## 40106 Switching - Grounded input true bypass onboard relay with strain relief

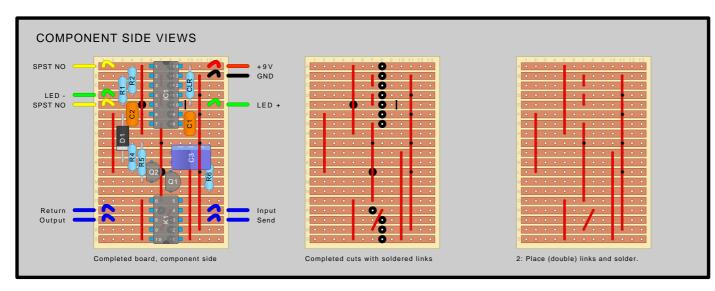
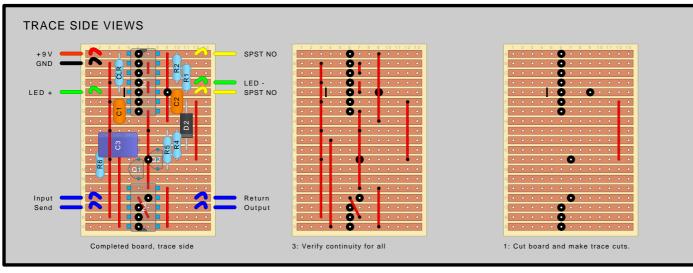
Removed unnecessary cut at transistor

Changed position of links

Changed electrolytic cap mounting orientation

Due to IC1 not getting proper supply voltage, a 100 uF capacitor was soldered on the trace side. This capacitor may affect functionality - IT IS NOT ON THE SCHEMATIC OR LAYOUT!

100n and 200n caps were replaced with 4n7 and 47n for proper switching action
